Access Compliance Report

Public Rights-of-Way

(Curb Ramps)

Intersection ID: 10036927	Main Street: S_SHARON_AMITY_RD	Cross Street: N/A	Location: NE
ADA ID: 5057A598863E	Ramp Type: Directional1	Initial Pass/Fail: Fail	Overall Compliance: No
Severity Score: 1.25			
Codes/Mitigation Info/Possible Solution		Field Measurements/Component Compliance

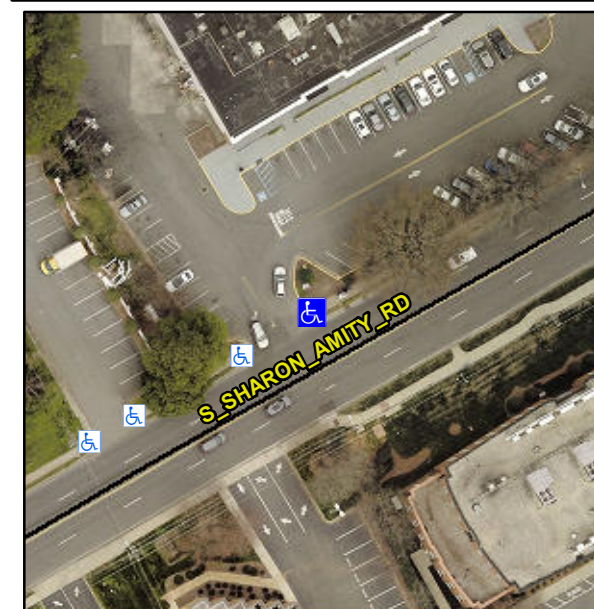
R304.5.3

Remove & Replace Entire Ramp.
